Docket Item #9

**Development Special Use Permit #2006-0006
3650 Wheeler Avenue-Lindsay Lexus**

Application	General Data	
Project Name: Lindsay Lexus	PC Hearing:	April 7, 2009
	CC Hearing:	April 18, 2009
	If approved, DSUP expiration:	April 18, 2012 (36 months)
	Site Area:	76,669 sf (1.76 acres)
Location: 3650 Wheeler Avenue	Zone:	Industrial
	Proposed Use:	Car storage, Repair/Preparation, Clean up services
	Gross Floor Area:	38,428 sf
Applicant: Lindsay Cadillac Co., Inc., represented by J. Howard Middleton, attorney	Small Area Plan:	Seminary Hill
	Green Building:	Providing 13 points under the LEED system

Figure 1: Site Plan – Phase I

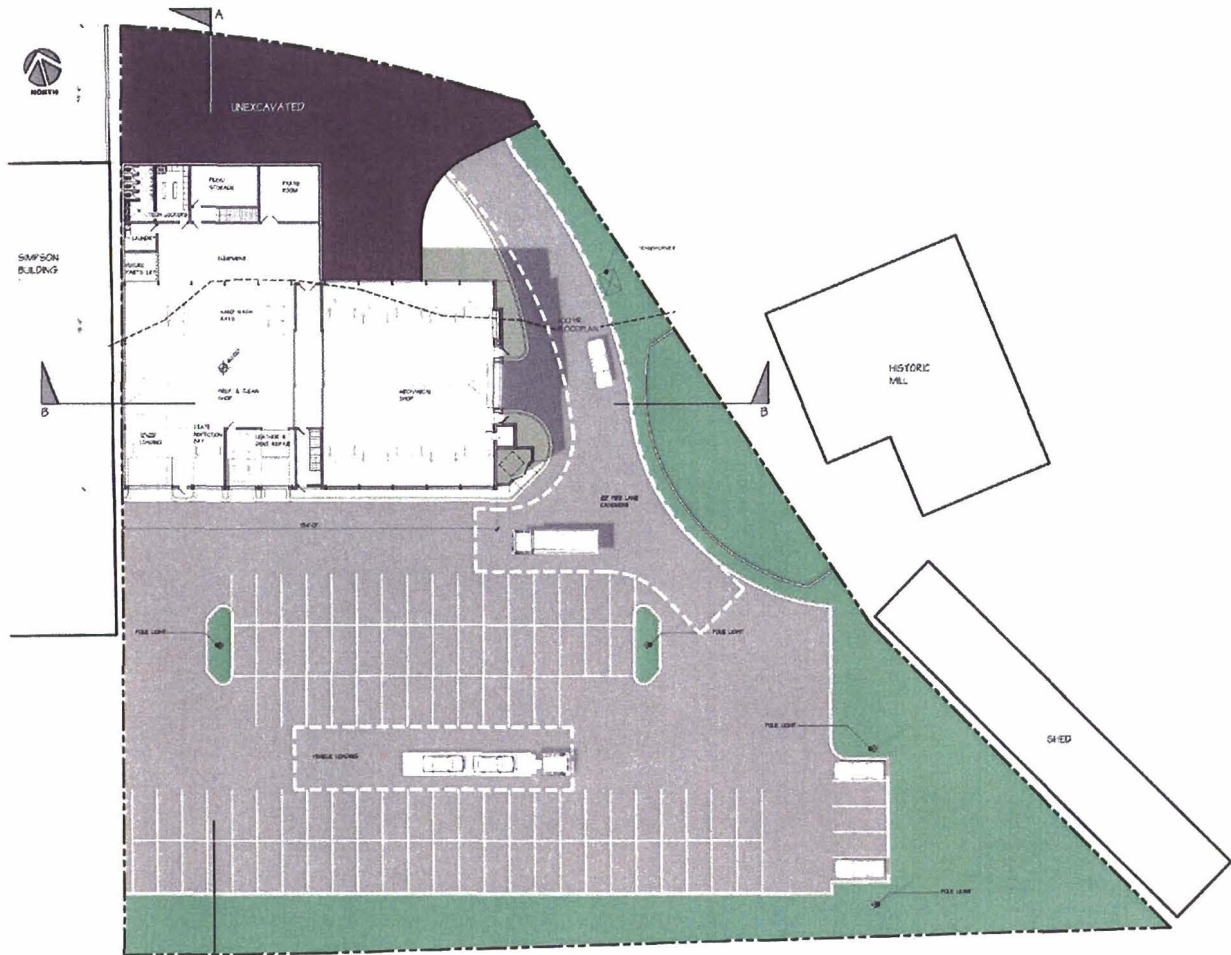
One area of concern for staff was the placement of a large transformer with a seven-foot-tall masonry enclosure structure within this open space area and viewshed of the historic mill. Because of the existing 100-year floodplain, the transformer must be provided in this location as it serves the Flippo Construction site and well as the subject site. Staff has recommended that the enclosure be eliminated and that the transformer be screened with a naturalistic mix of plant materials so that it blends in with the landscaped open space.

- d. Reconfigure the ADA parking spaces, correct the parking space dimensions and provide additional open space area between the parking spaces and the administrative building as generally depicted in Attachment #1. The landscape plan shall be revised in coordination with this requirement.

- e. Eliminate the enclosure around the transformer, minimize the size of the concrete pad, and screen the transformer from view along Wheeler Avenue with a variety of plants. The service opening for the transformer shall be oriented to provide the least objectionable view.

- f. The transformer location is limited by pre-existing conditions. The final placement shall minimize impact on the historic mill. The landscape plan shall prioritize screening of the transformer with a natural planting scheme.

Figure 6: Vehicle storage building elevations – applicant proposal

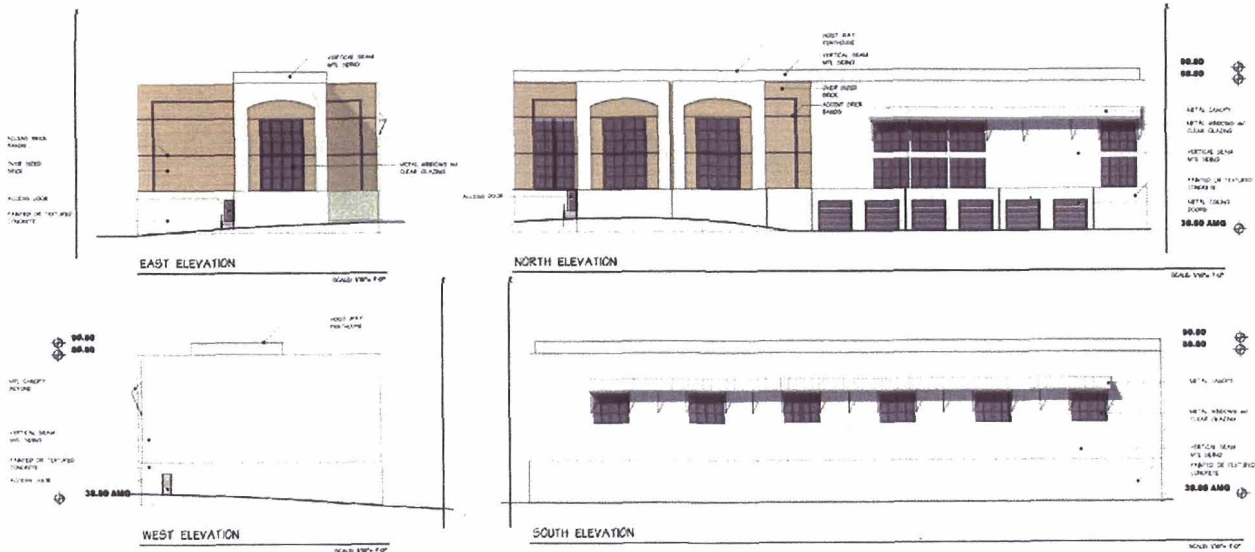
Staff and the applicant have worked substantially on the design of the storage building. The design of this building has evolved from incorporating elements recalling brick materials found in the old grist mill structure to simplifying the language by extending the metal-cladding and concrete expression. Staff has added conditions of approval addressing this design refinement.

Figure 7: Staff recommended refinements to north and east facades of the vehicle storage building

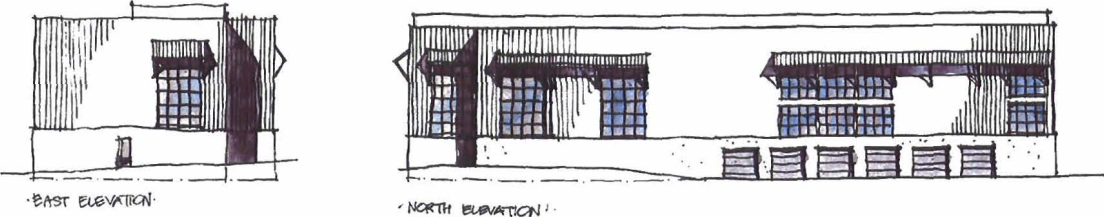
Even though the use of vehicular lifts in the current proposal has substantially reduced the size of this structure, building materials were streamlined to deemphasize the horizontal lines. Metal siding with vertical seams and windows of various proportions on the north façade add articulation to the building exterior.

15. The applicant shall provide the following building refinements to the satisfaction of the Director of P&Z:
 - a. Refine the design of the vehicle storage garage as depicted in Attachment #2.
 - b. Color architectural elevations showing various glazing types shall be submitted during final site plan review. Glazing samples shall be provided for approval. (P&Z)
16. The final materials, details, and color selection for both buildings shall be reviewed and approved as part of the final site plan review. (P&Z)
17. The applicant has agreed to incorporate sustainable design elements and innovative technologies into the project and achieve 13 points under the LEED Green Building Rating System for New Construction. As part of the Final Site Plan review process, the applicant shall explore the possibility of incorporating a cistern into the project. (P&Z)(RP&CA)(T&ES)
